Accessibility Review Report – DA Review

Project Title: Night Cap Hotel Development
Stage 2 – 31-45 Frenchs Forest Rd, Frenchs Forest

Date: 26 March 2021

Report Version: 20422_ADR_DA_v1.1

Figure 1 – Site Plan Mark-up

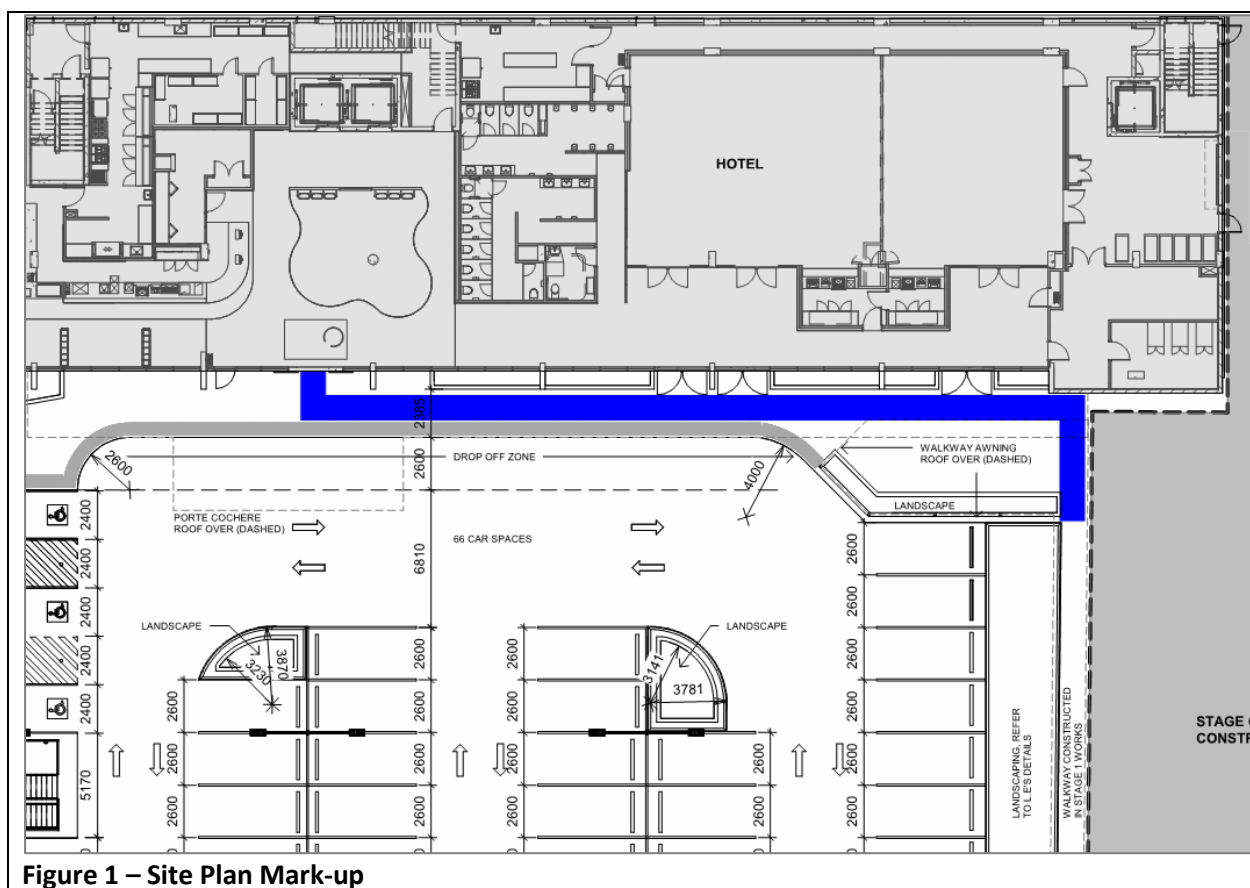
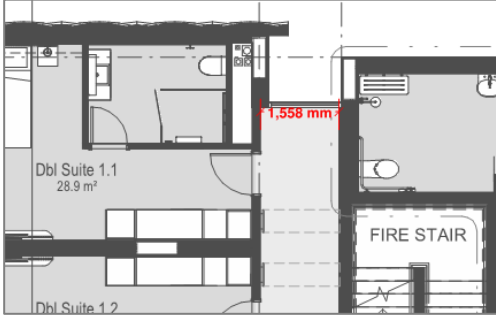
DtS Provision	Comment(s)/Recommendation(s)	Status
<p>An accessway must be provided to a building required to be accessible –</p> <ul style="list-style-type: none"> • from the main points of pedestrian entry at the allotment boundary; and • from another accessible building connected by a pedestrian link; and • from any required accessible carparking space on the allotment. <p>In a building required to be accessible, an accessway must be provided through the principal pedestrian entrance, and –</p> <ul style="list-style-type: none"> • through not less than 50% of all pedestrian entrances including the principal pedestrian entrance; and • in a building with a floor area more than 500m², a pedestrian entrance which is not accessible must not be located more than 50m from an accessible pedestrian entrance. <p>except for pedestrian entrances serving only areas exempted by D3.4.</p>	<p>The subject hotel building is being constructed as Stage 2 of a larger staged development.</p> <p>Access is required from the allotment boundary to the subject building and to all buildings required to be accessible connected by a pedestrian pathway.</p> <p>ABE Consulting is reviewing the new pathways being constructed as part of the Stage 2 Works only for the purpose of the BCA Cl. D3.2 assessment as indicated blue below and the remainder of the site is approved by a third party.</p> <p><i>N.B. – The existing site and Stage 1 have not been assessed as part of this report.</i></p>	DD
